Abbey House, Abbey Close ABINGDON 0X14 3JE Ref: P23/V2666/3PC

# STATUTORY CONSULTATION UNDER SECTION 42 OF THE PLANNING ACT 2008.

At: Botley West Solar Farm

This is the response of the Vale of White Horse District Council (VWHDC) to the Statutory Consultation and notification pursuant to Section 42 of the Planning Act 2008 to the NSIP project for the Botley West Solar Farm, a large solar farm to the west of Oxford within the districts of West Oxfordshire, Cherwell and Vale of White Horse.

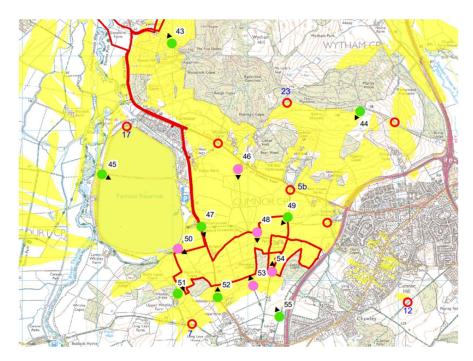
There are several places where views have not been taken, including those highlighted in the Cumnor Neighbourhood Plan such as Viewpoint 5b, 12, 23, 7, 12 and 17. These are highlighted on the plan extract below along with additional Prow, roads, and the Wytham permitted path network. Additional viewpoints are requested from these locations. Once the Substation ZVT is undertaken there may also be additional viewpoints that need to be included.
